# ADDENDUM No. 1

## RFP No. 24-23

### Barton/Bandemer Park Pedestrian Tunnel Project

DATE: 02/12/2024 PROJECT: 1022180210 MDOT/AMTRAK RAIL CITY/VILLAGE/TOWNSHIP: CITY OF ANN ARBOR COUNTY: WASHTENAW STATE: MI SCALE: N 1"=20' SHEET: 17 OF 80

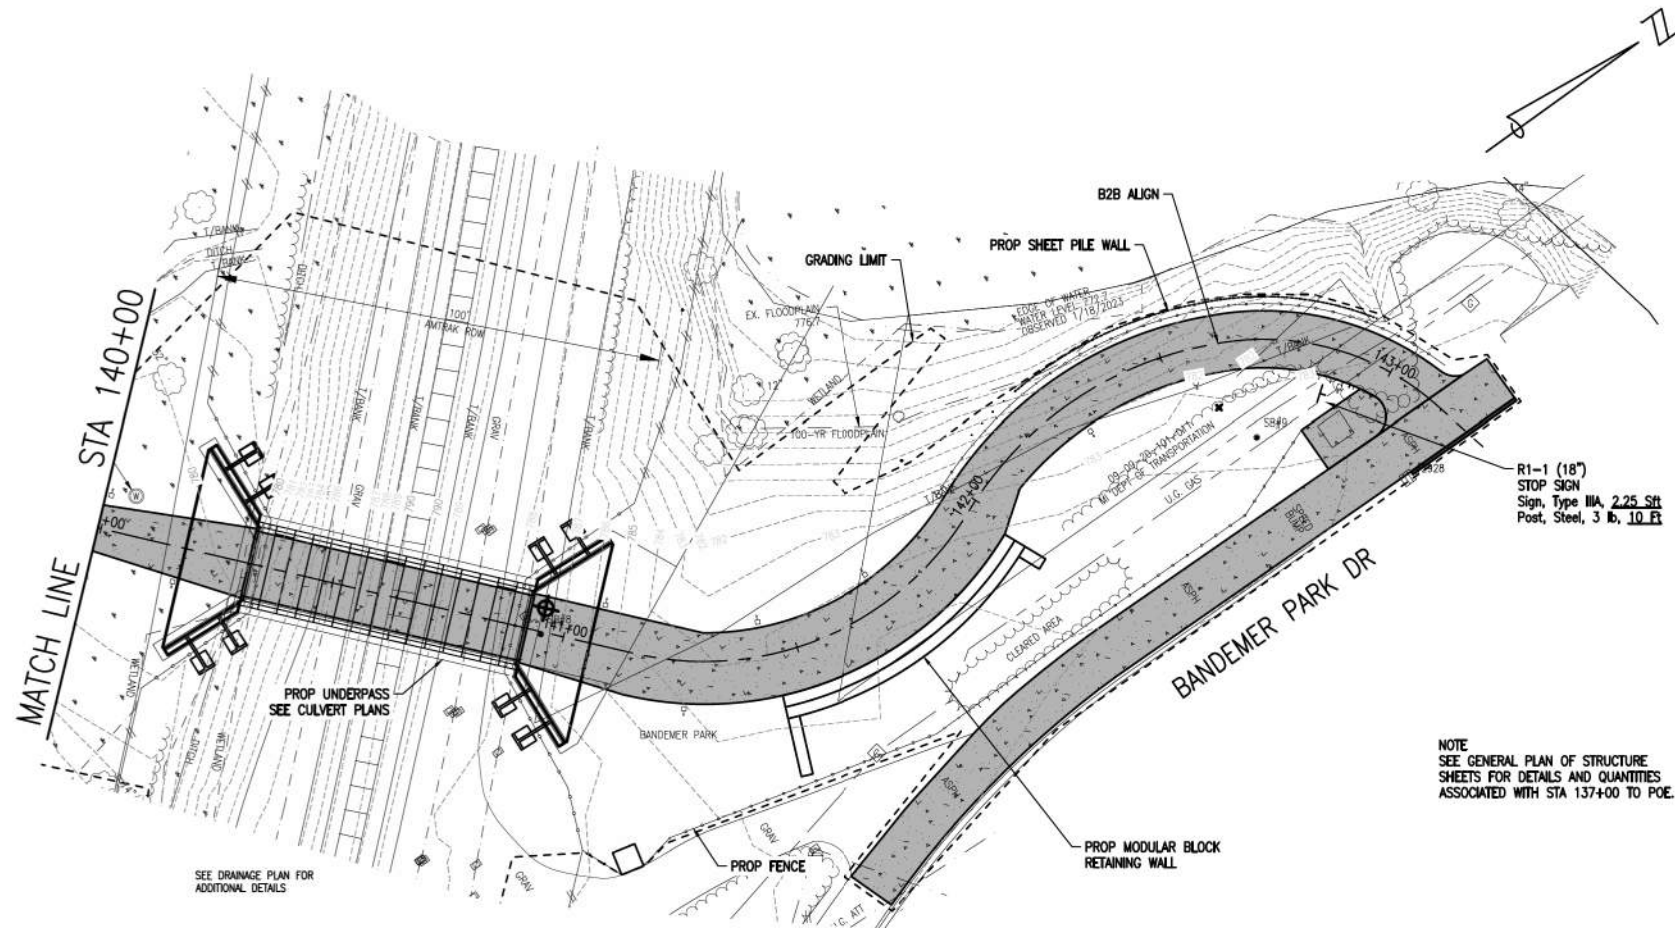
Plans Page 16 of 80	Replace plan sheet. Updated profile (slight raise of 2-inches at the timber pedestrian bridge).
Plans Page 17 of 80	Replace plan sheet. Updated miscellaneous quantities and turned off existing fencing in the restoration plan.
Plans Page 18 of 80	Replace plan sheet. Updated profile and turned off existing fencing in plan.
Plans Page 19 of 80	Replace plan sheet. Expanded coverage to include the entirety of the relocated stream. Added notes to remove existing concrete foundations to 1'-0" below finished grade where encountered in the grading. Updated miscellaneous quantities. Updated drainage layout and pipe sizes.
Plans Page 20 of 80	Replace plan sheet. Revised concrete jointing pattern.
Plans Page 21 of 80	Replace plan sheet. Removed sign details. All proposed signs are per the Michigan Standard Highway Signs Manual.
Plans Page 22 of 80	Replace plan sheet. Added work to construct a concrete curb along the path edge for a small portion of the path that parallels the park road (from the existing drainage structure to the north limits of pathway work).

45 of 80

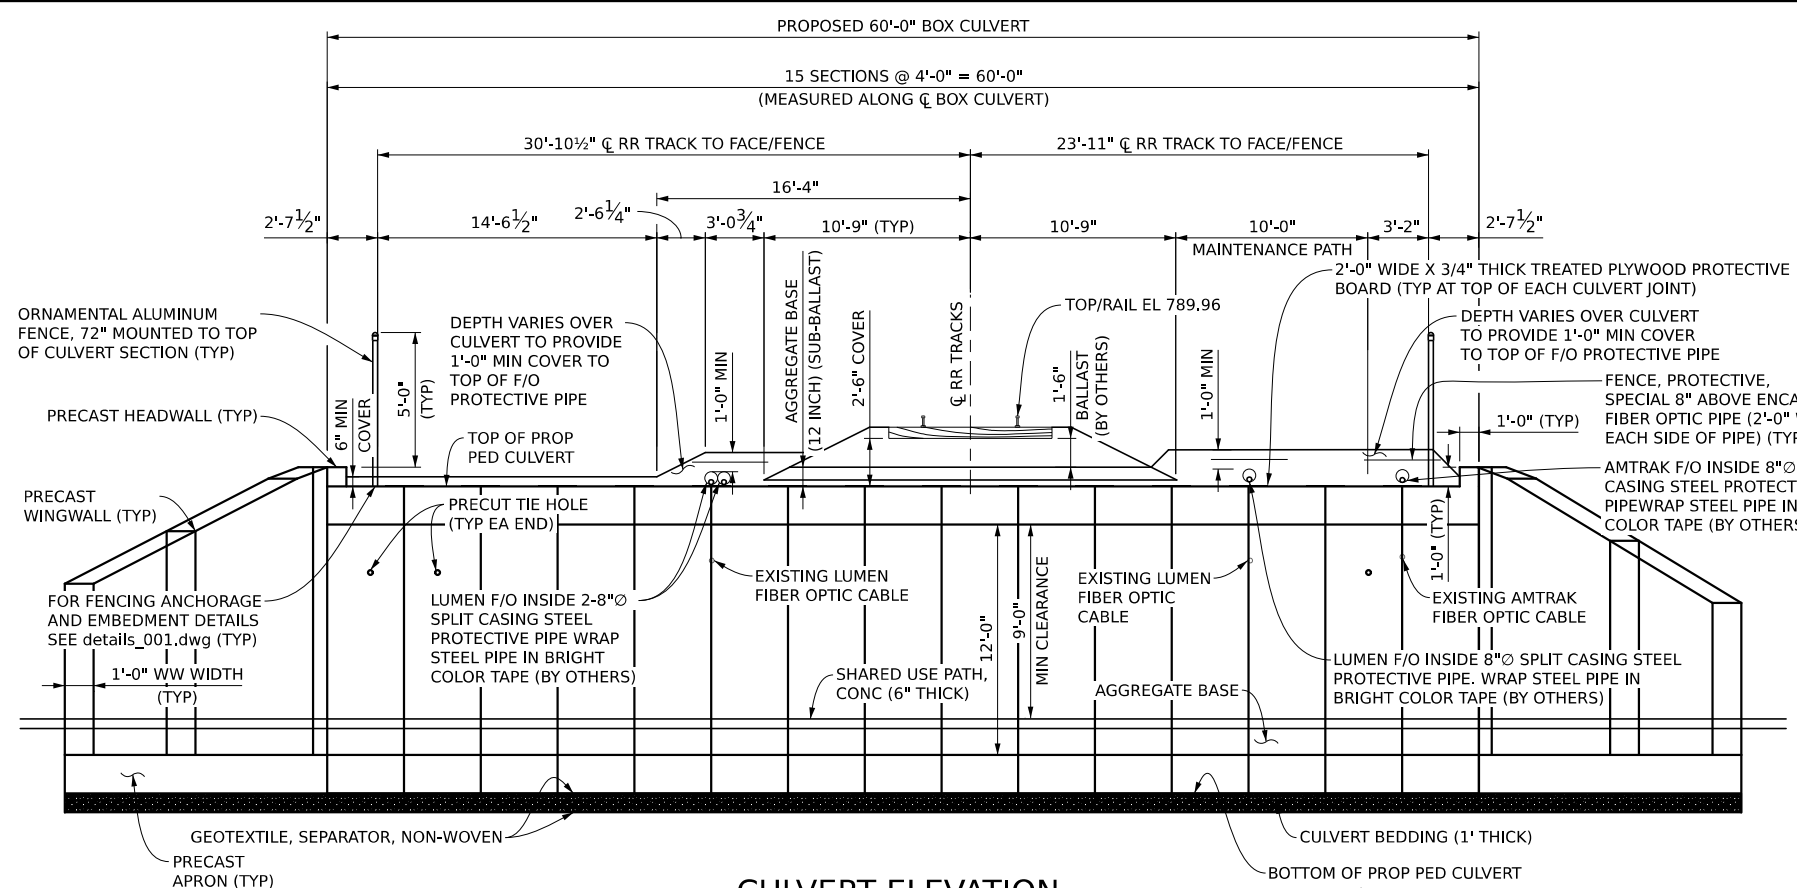
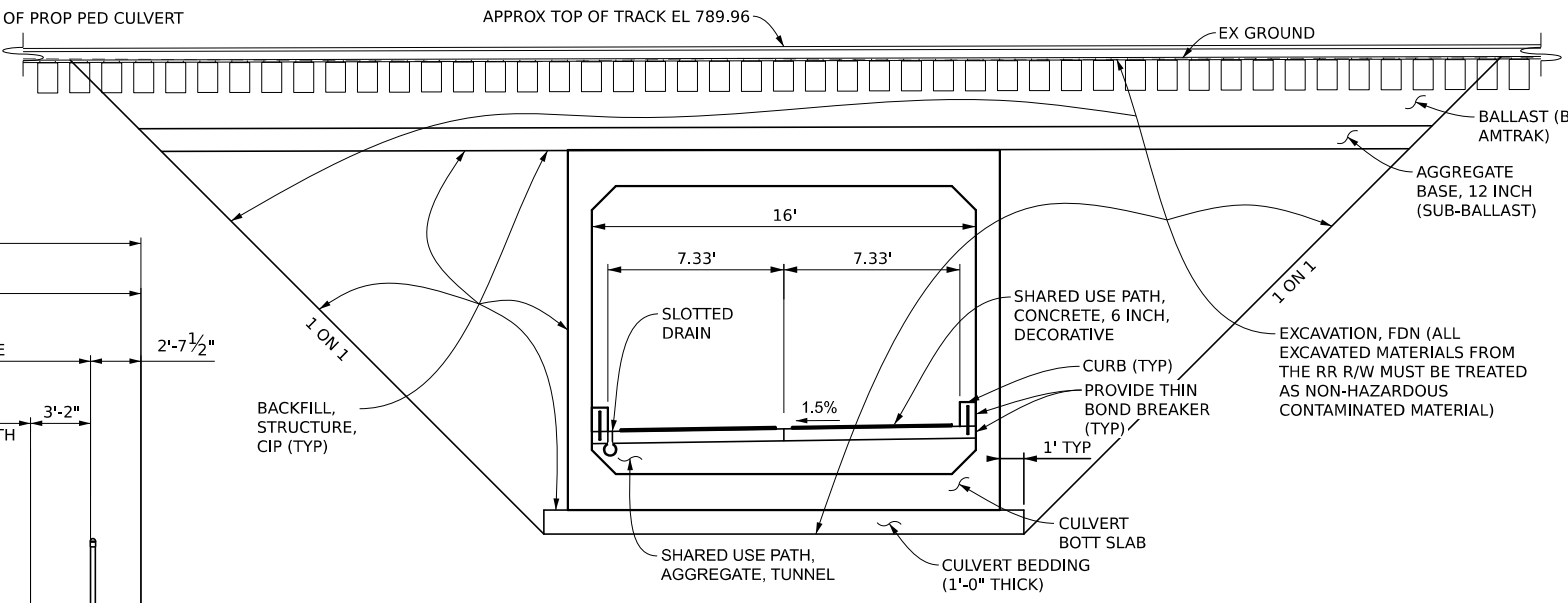
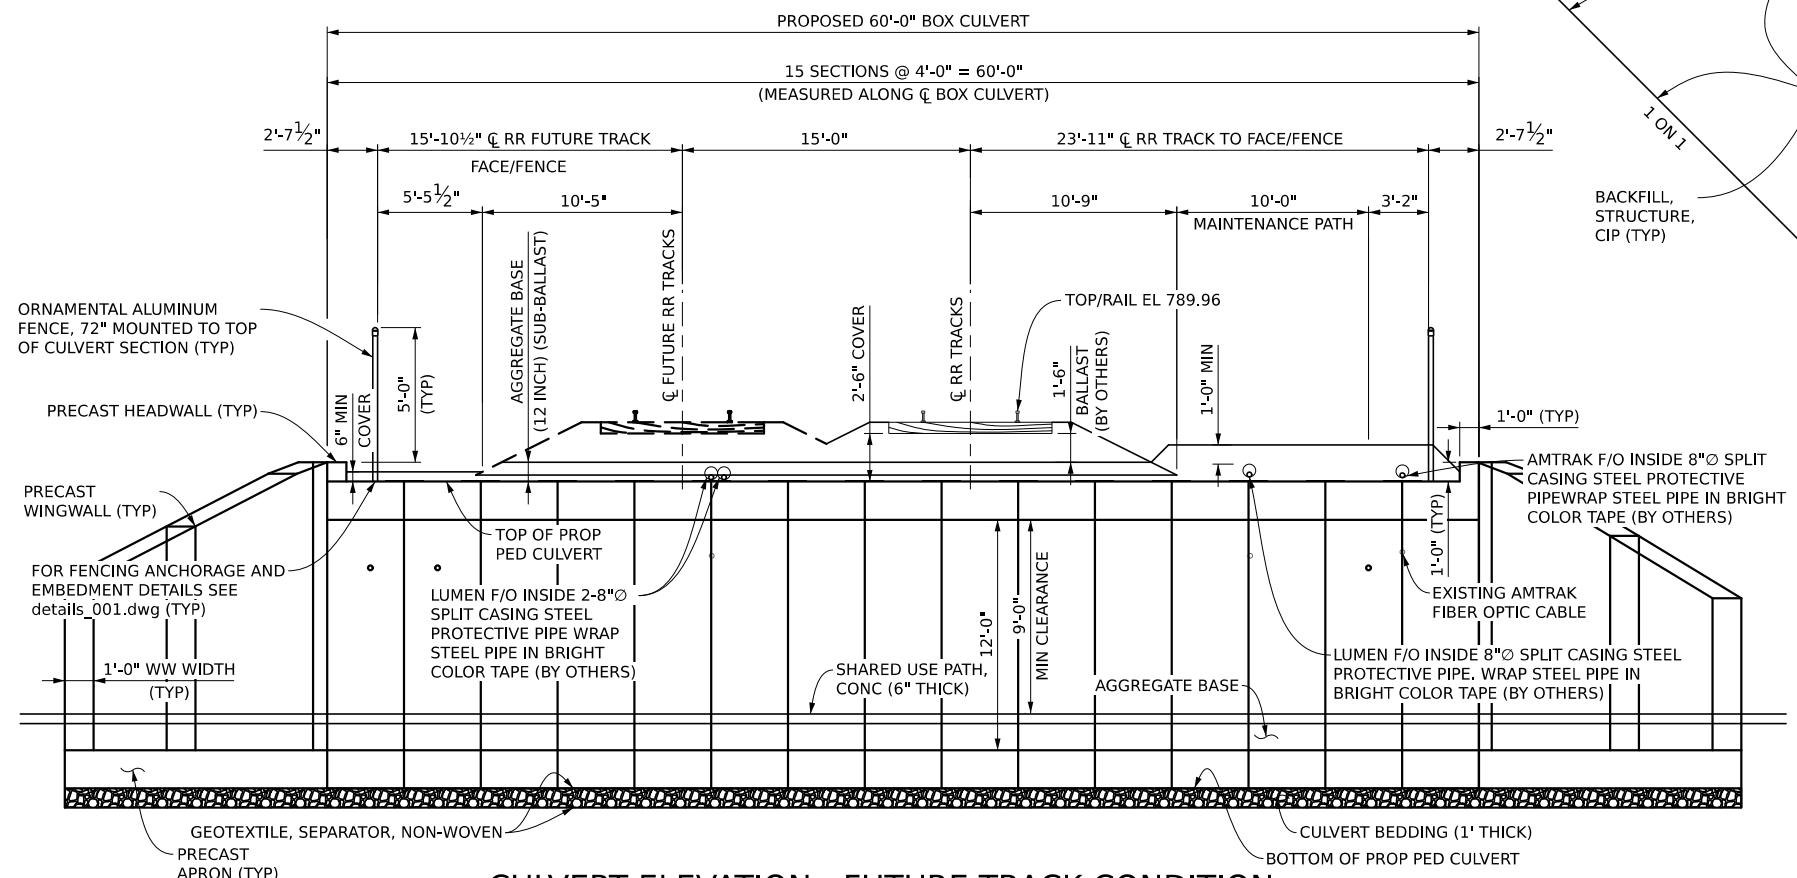
Plans Page 45 of 80	Replace plan sheet. Updated profile upwards 2-inches at the timber pedestrian bridge.
Plans Page 47 of 80	Replace plan sheet. Removed grading details from Section A-A. Updated culvert width of walls to be 1'-0" in End Culvert Elevation and clarified where Liner, PVC, 30 Mil, Spec is paid for. Updated miscellaneous quantities.
Plans Page 48 of 80	Replace plan sheet. Added dimension of Fence, Protective, Special.
Plans Page 49 of 80	Replace plan sheet. Updated miscellaneous quantities.
Plans Page 52 of 80	Replace plan sheet. Updated size of panels inside culvert.
Plans Page 53 of 80	Replace plan sheet. Updated details for pedestrian bridge including member sizes and dimensions.
Plans Page 54 of 80	Replace plan sheet. Updated details for pedestrian bridge including member sizes and dimensions.
Plans Page 55 of 80	Replace plan sheet. Updated quantities and added size and depth to light pole base.
